**Response to RAI 1.1:**

**Response RAI 9.1:**

**Response to RAI-11.2.a**

Figure 1 Nearest Residence Location

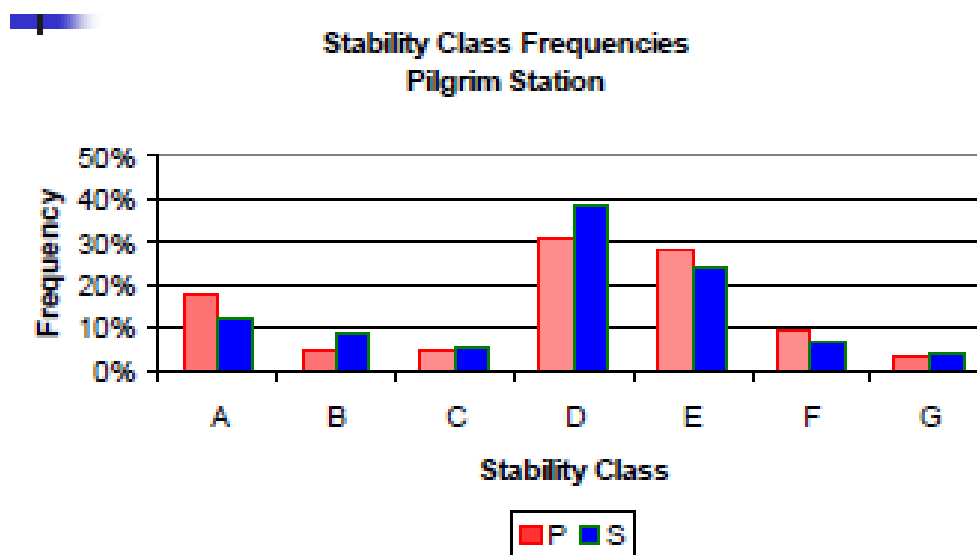
The nearest residence is approximately 200 meters away from the reactor facility stack in the west-north-west direction as shown on Figure 1. The dose to a member of the public, due to the assumed continuous full-power operation Ar-41 airborne release was calculated using the following formula (see also response to RAI-13.5.e):

Figure 2 Pasquille Stability Class Frequency Distribution

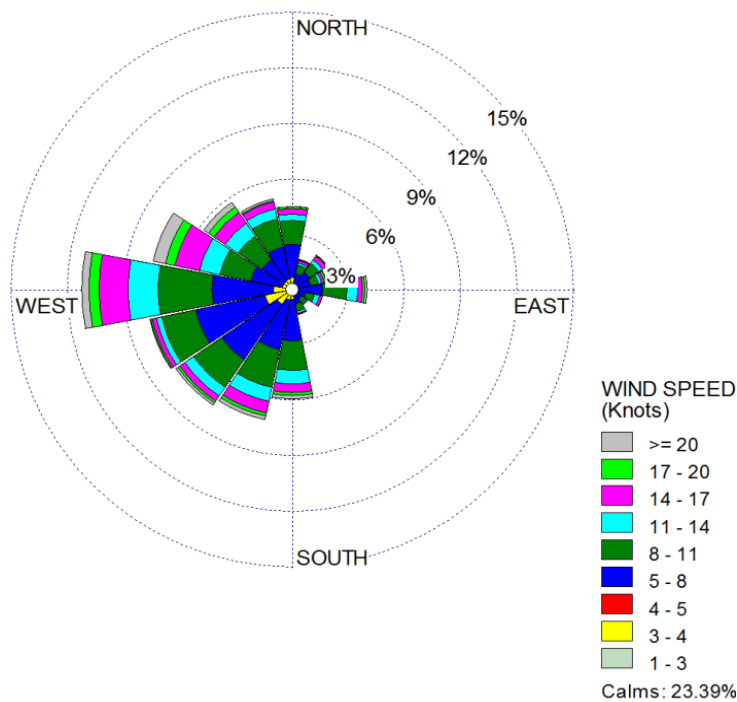
The available meteorological data, while including wind speed and direction, do not provide any indication of the stability classes for each specific measurement point. In order to illustrate the effect of historical stability class influence on the dose calculation, a typical stability class frequency distribution may be considered from the Pilgrim nuclear plant located in Plymouth Massachusetts. Figure 2 shows the stability class distribution frequency that was derived from measured temperature data using a weather tower with instruments at 10 and 60 meters height<sup>1</sup>. An approximate effective dose value may be derived using the stability frequency distribution as a weight factor for each dose value as calculated by the above formula and ARCON96 for a specific stability class at a given distance. While site specific stability class frequency data is not available for the UMLRR, the stability class frequency averaged dose calculated using the Pilgrim distribution data illustrates the potential effect of varying stability class conditions.

Figure 3 Wind Direction Distribution for Hanscom Air Force Base  
January 1<sup>st</sup> 2013 – December 31<sup>st</sup> 2013

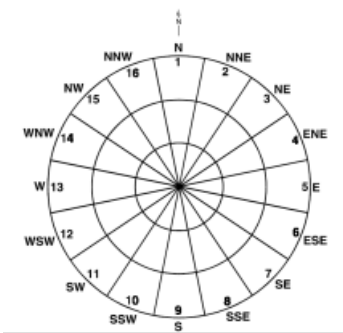
Figure 3 shows the final wind rose data being used in all calculations both for the Ar-41 and MHA fission product releases. The previous figures were incorrectly given using an earlier version of the meteorological data.

Figure 3 shows the final wind rose data being used in all calculations both for the Ar-41 and MHA fission product releases. The previous figure was incorrectly given using an earlier version of the meteorological data.

**Fig. 1 Various views of the full storage rack model containing nine (9) fresh fuel elements.**

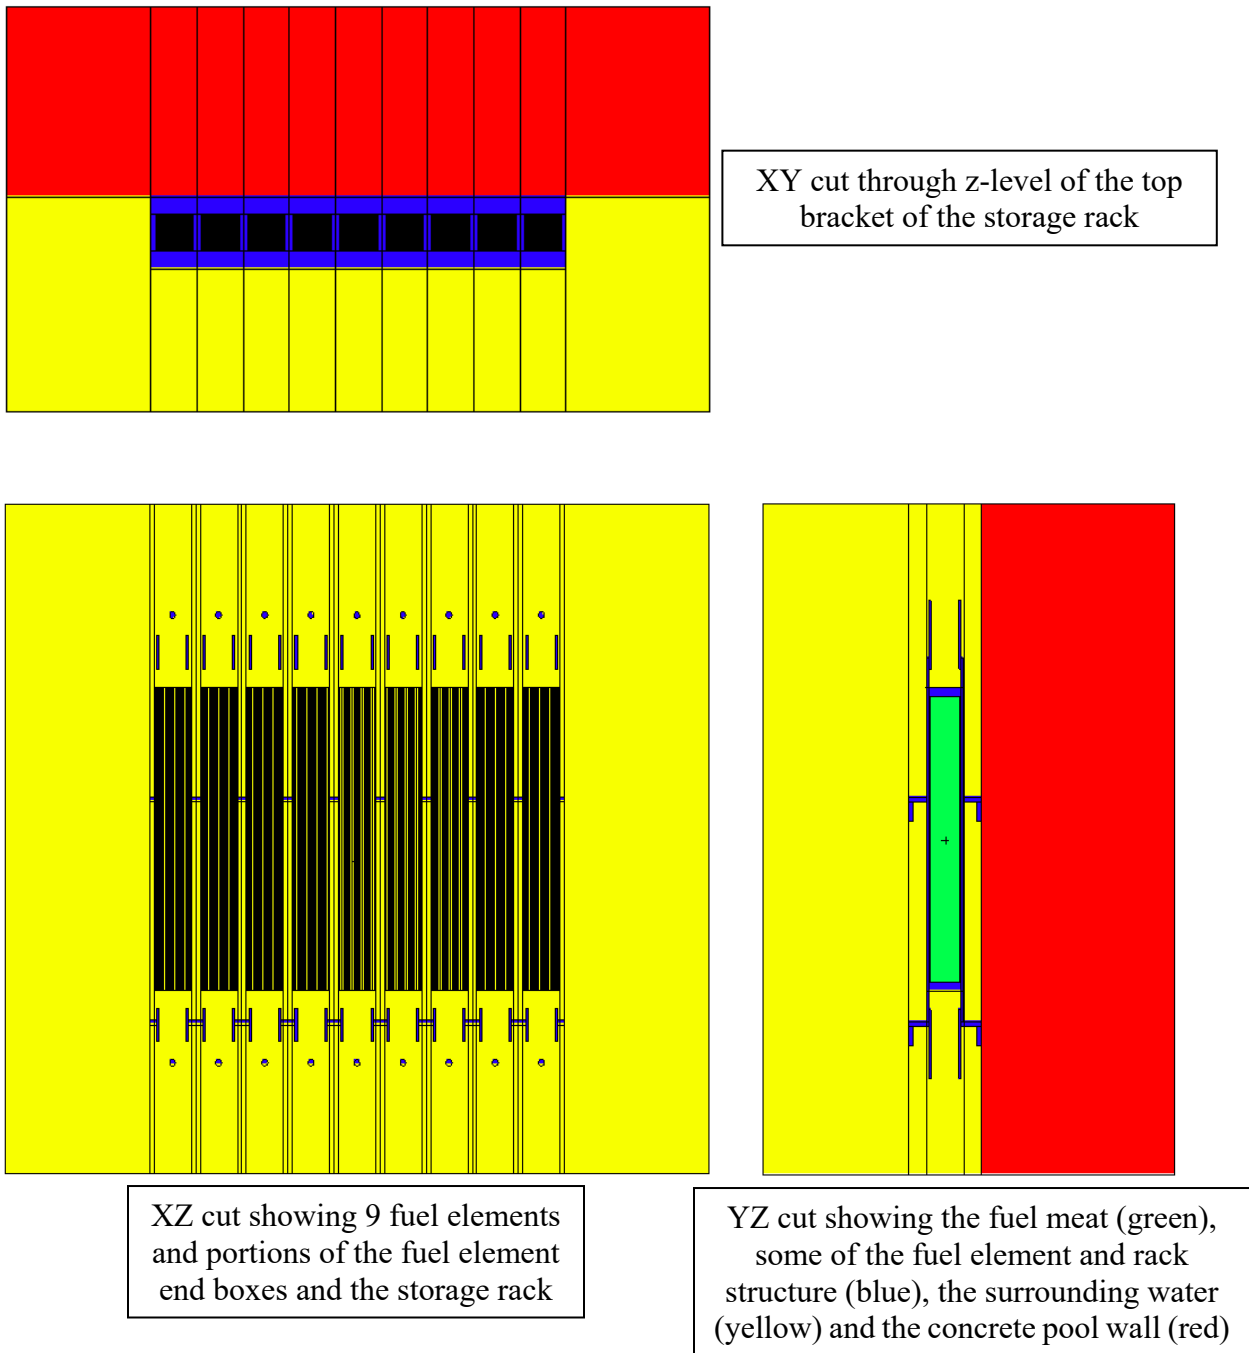
The MCNP model for the current storage rack criticality safety analysis used the same base low enriched uranium (LEU) fuel element model as described in Refs. 4-5. This pre-existing model of a fresh fuel assembly represented the starting point for the current computational study. With this base, a series of storage rack models were developed which included a linear array of the fresh

**Fig. 2 Criticality level versus element spacing (water reflected model).**

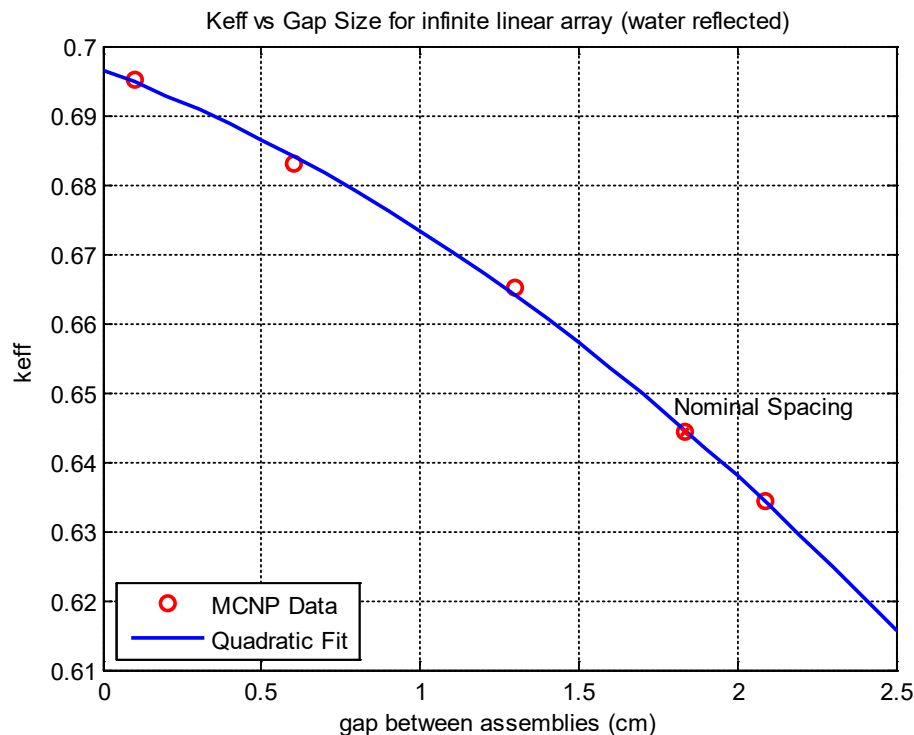
**Center-to-Center Spacing:** The first model addressed did not include the rack structure or the concrete wall -- only water reflectors were used. The model included a single fuel assembly with 20 cm of water above and below the fuel end boxes and 30 cm of water on the front and back sides (in the y-direction) -- these represent infinite water reflectors in these directions. In the x-direction, the gap between fuel elements (or center-to-center spacing) was varied and the outer boundaries used reflected boundary conditions to represent an infinite linear array of fuel elements. The results of this set of calculations are summarized in Fig 2.

There are two important results illustrated here -- that the maximum multiplication factor for an infinite linear array of fuel elements is less than 0.7, and that the nominal spacing for the UMLRR storage rack of 3.78 inches (9.60 cm) even reduces this value further.

**Fig. 5** Criticality level versus number of rows of nine (9) fuel elements (final rack model)

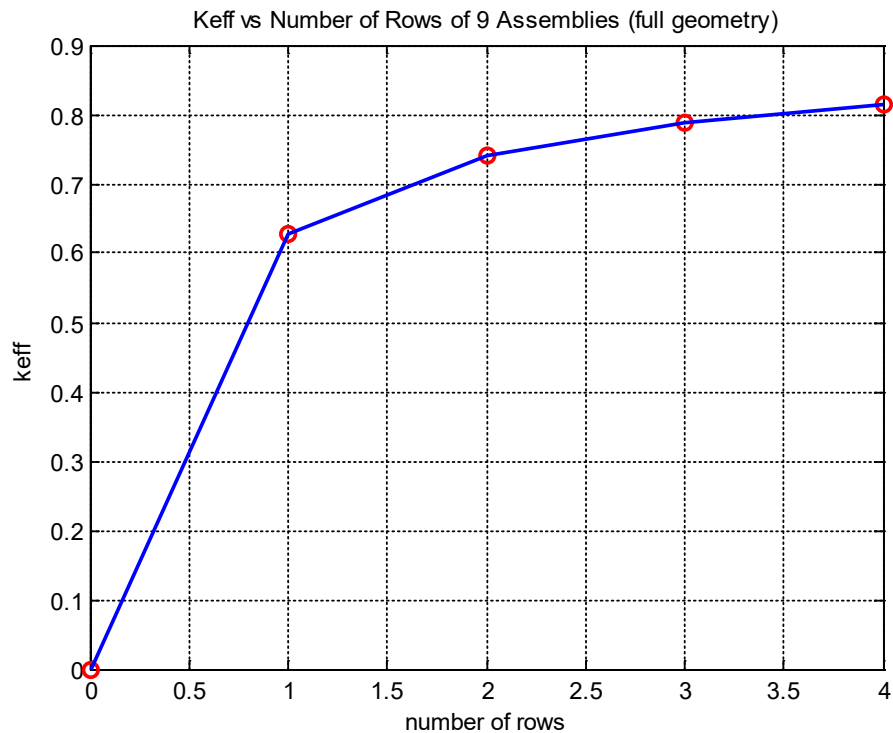
As apparent from Fig. 5, a 1×9 linear array (which is the UMLRR arrangement) is very subcritical, but even a 4×9 array has a  $k$ -value well below the regulatory limit of  $k_{\text{eff}} < 0.9$  for a fuel storage geometry. This final analysis simply shows that there is essentially no way for the single-row UMLRR rack design to support a critical configuration. Even if multiple racks were placed side by side (which is simply not possible with the current rack design and placement along the walls of the UMLRR pool), the overall fuel storage arrangement stays well subcritical -- and none of the calculations performed in this study use any Boral poison material!
